VILLAGES AT STERLING RANCH

GRADING & EROSION CONTROL PLAN

VILLAGES AT STERLING RANCH
CONSTRUCTION PLANS
TITLE SHEET

V4_Grading & Erosion Control Plan.pdf Markup Summary

STORMWATER ENTERPRISE — VEHICLE TRACKING CONTROL — APPROVED: CHIEF ENGINEER — ISSUED: 10/7/19 — REVISED: 8/19/2020 — DRAWING NO. 900-VTC

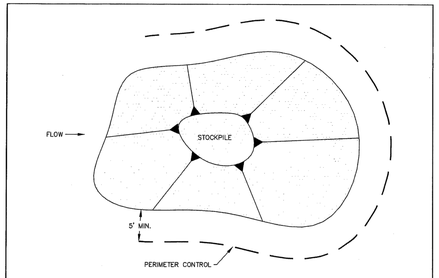
Replace with EPC approved VTC detail (VT-1 and VT-2 in DCMv2, Chap 3.3) or revise to be 75ft min length.
